CITY OF MADISON
CITY ENGINEERING DIVISION
DEPARTMENT OF PUBLIC WORKS
PLAN OF PROPOSED IMPROVEMENT

1 & 15 ELLIS POTTER COURT

CITY PROJECT NO. 15157
CONTRACT NO. 9514

REVISION 1 - 08/05/25
- UPDATED SHEETS: P1, U1, L1

LANDSCAPING PLAN
1 & 15 ELLIS POTTER COURT
M:\DESIGN\Projects\15157\CAD\Streets\15157ENL.dwg

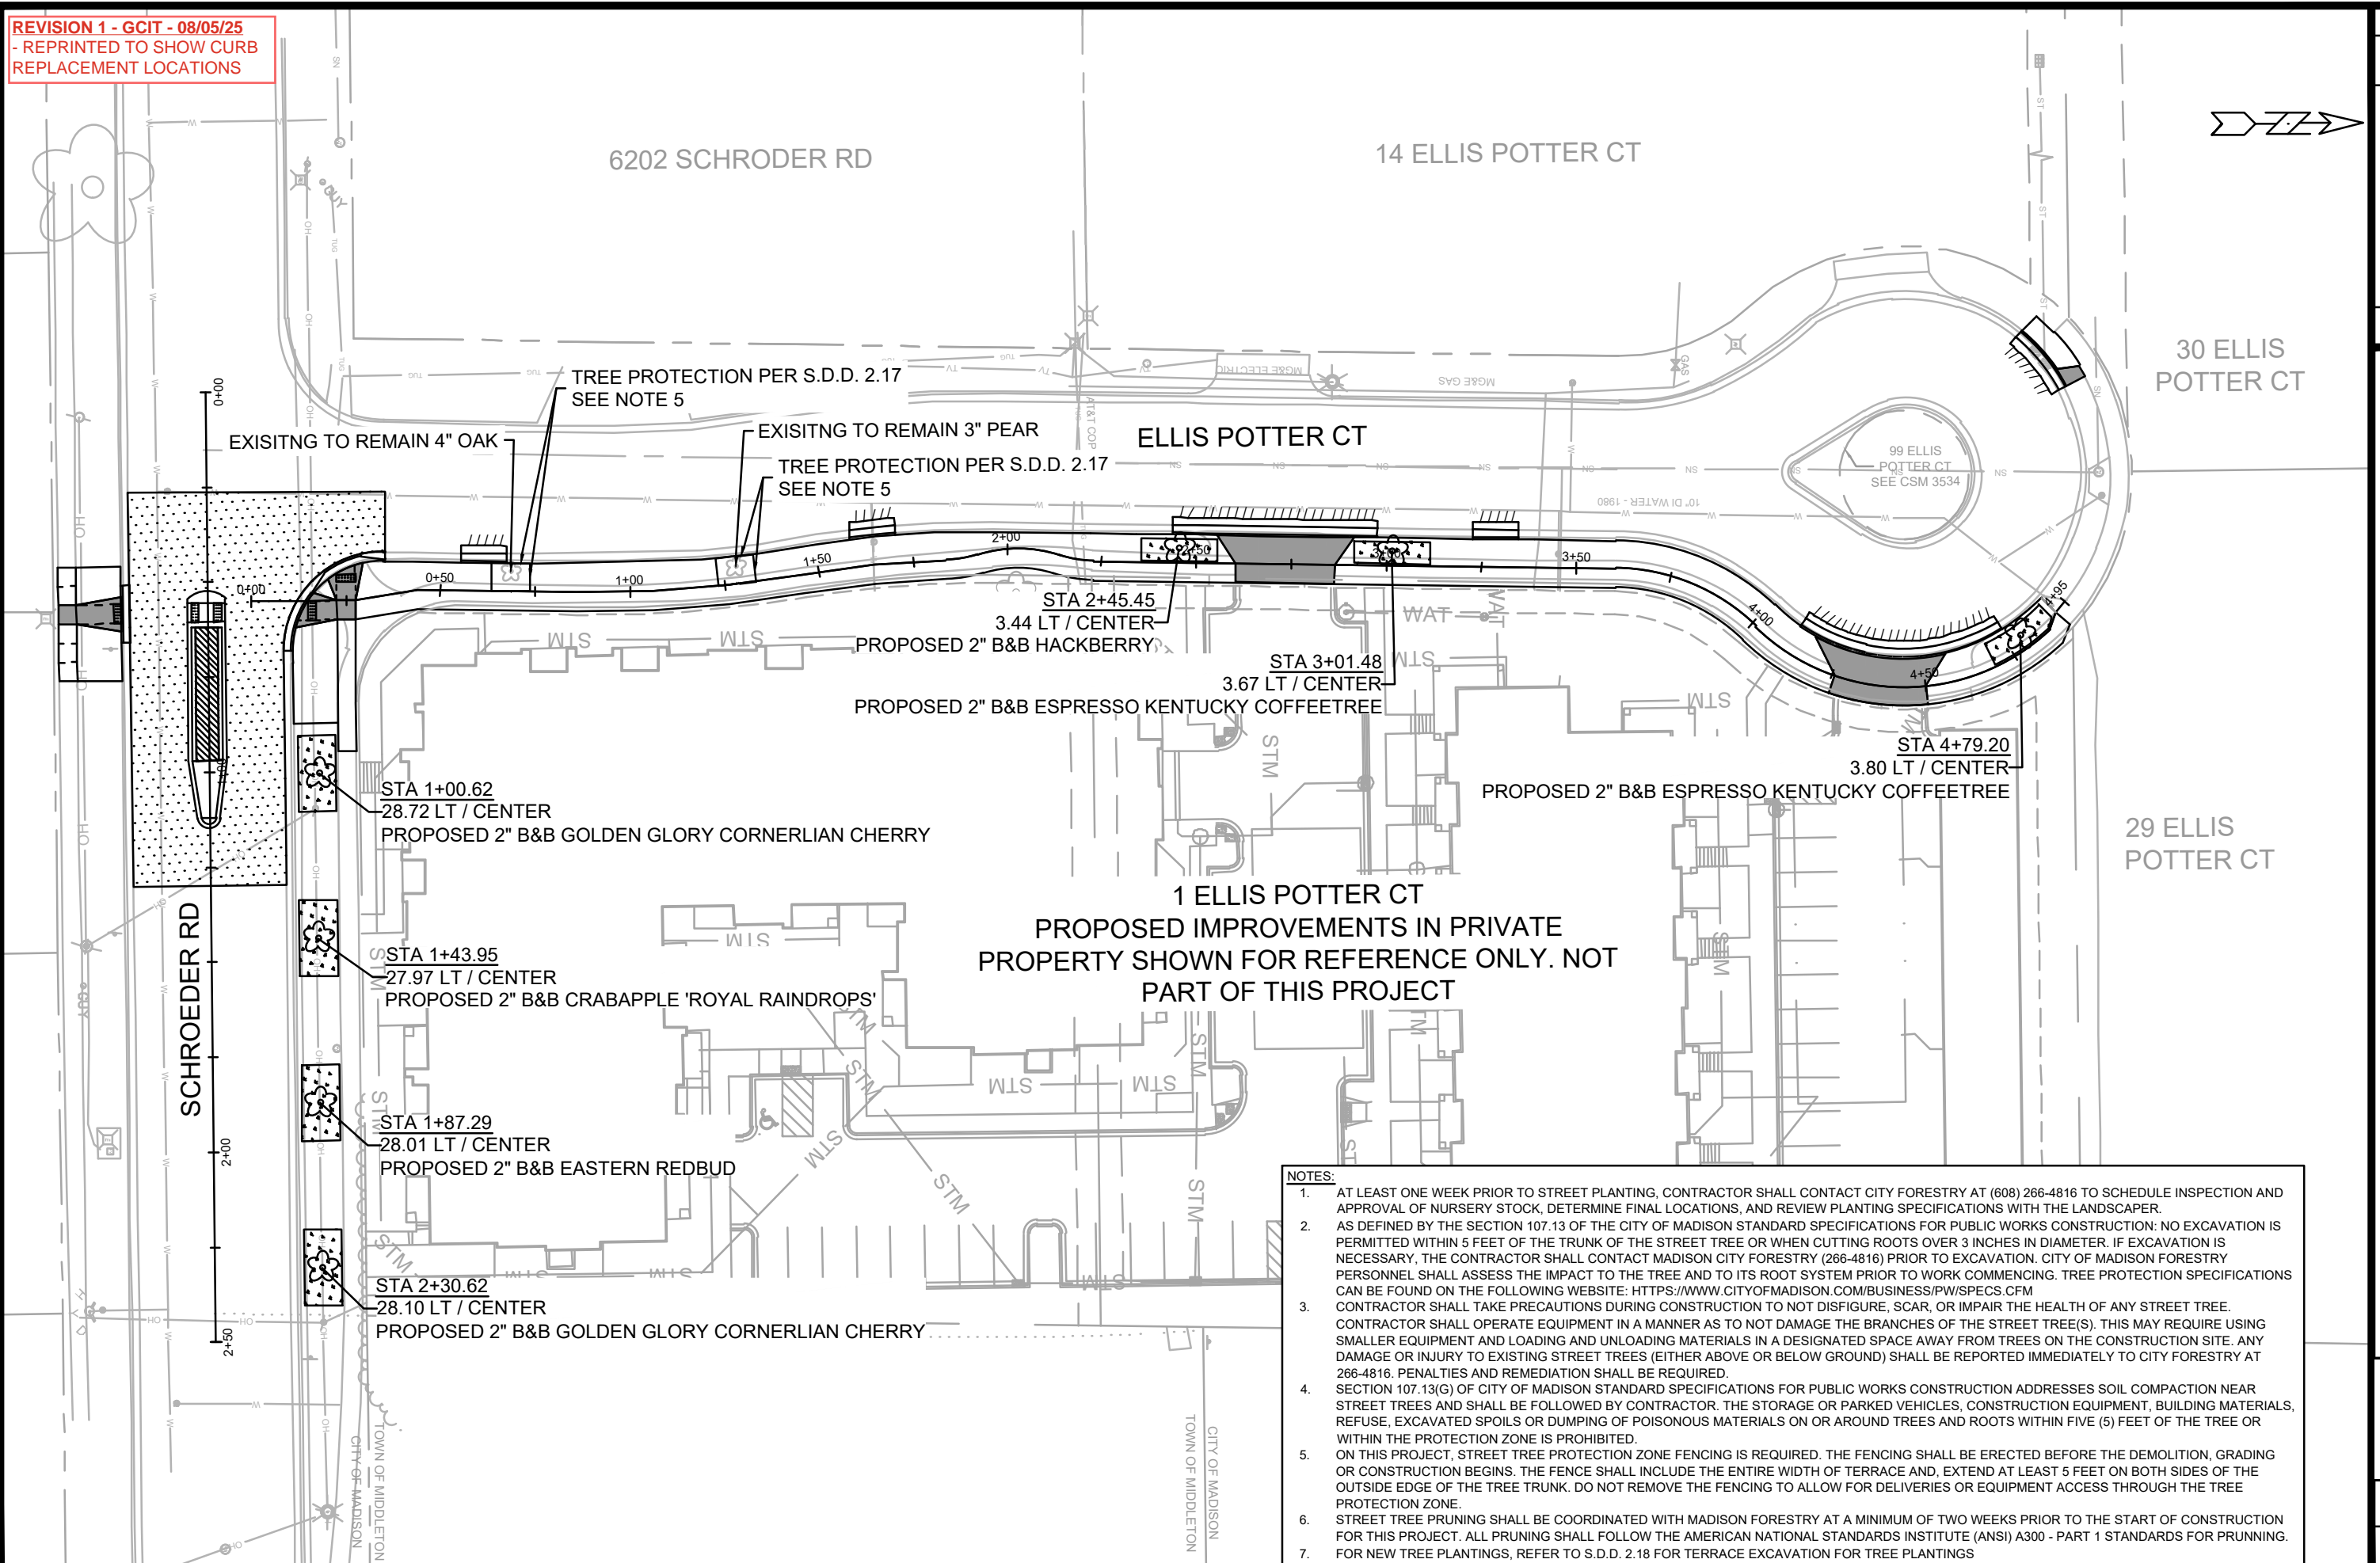
REVISION 1 - GCIT - 08/05/25
- REPRINTED TO SHOW CURB
REPLACEMENT LOCATIONS
